Office Action Summary	Application No. 10/502,297	Applicant(s) LUNDAHL, SVEN-INGVAR	
	Examiner Evan H. Langdon	Art Unit 3654

DETAILED ACTION

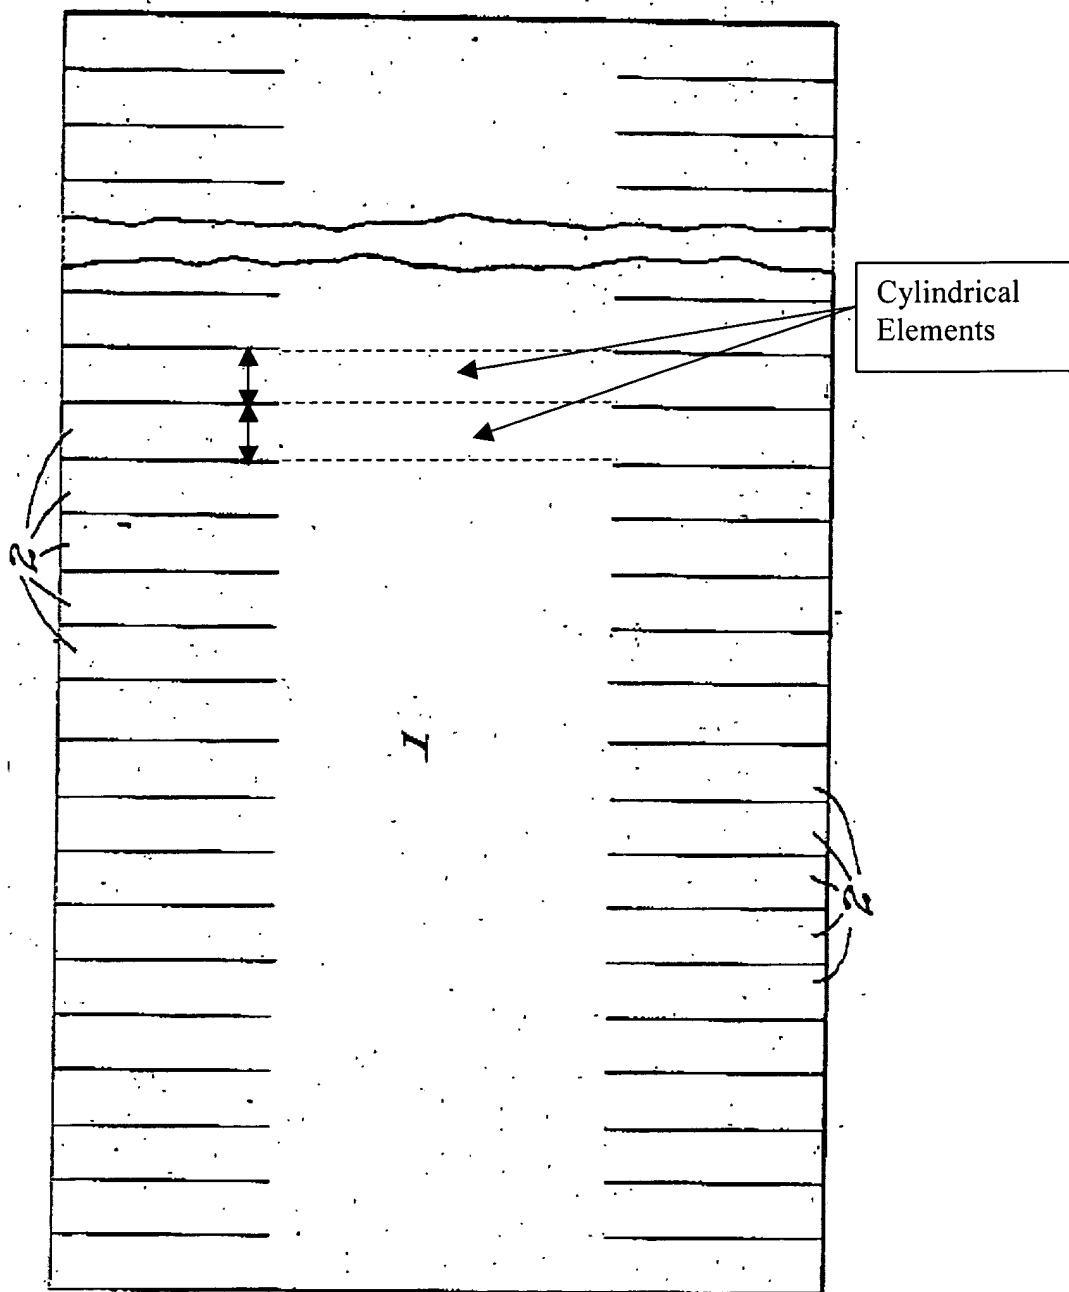
Balke discloses a bobbin, which has a cylinder 1 formed integrally with two circumferential end flanges 2 forming U-shaped channel; and

wherein the cylinder includes a plurality of cylinder elements each having a slightly curved, radially inner surface forming a circumference of the cylinder (see below)

each end flange 2 consists of a plurality of spaced apart radial flange elements 2 distributed along the circumference of the cylinder 1.

The plurality of spaced apart radial flange elements 2 defining plurality of cylinder elements as seen by the dashed lines above where each element has a slightly curved, radially inner surface forming a circumference of the cylinder as seen in Figure 2.
